## Spartan Fire, LLC

# Technical Service Bulletin TSB23-540-001

**APPLIES TO:** This service bulletin applies to certain 2014 through 2024 model year,

Gladiator, Metro Star, and KME Panther model emergency response chassis cabs built between October 9, 2014 and September 27, 2023.

Figure 2.1

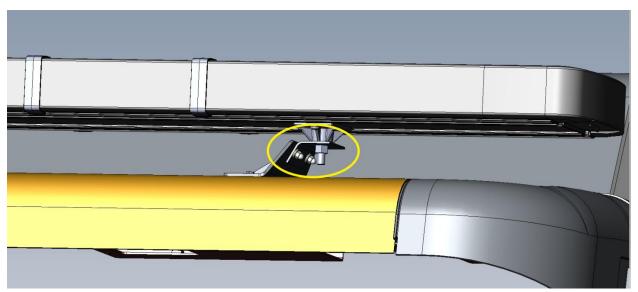
**CONDITION:** Certain vehicles equipped with 92 inch or longer roof mounted light bars

could experience fracture of the light bar mounting brackets.

**CORRECTION:** Replace light bar bracket with improved design bracket.

1) Locate light bar bracket on cab roof as shown in figure 2.1.

- 2) Support light bar so bracket circled above can be removed from both sides.
- 3) Remove brackets one at a time.
- 4) Install new bracket part number 4861-GG2-001 on each side.
- 5) Tighten fasteners appropriately.
- 6) Repair is complete.
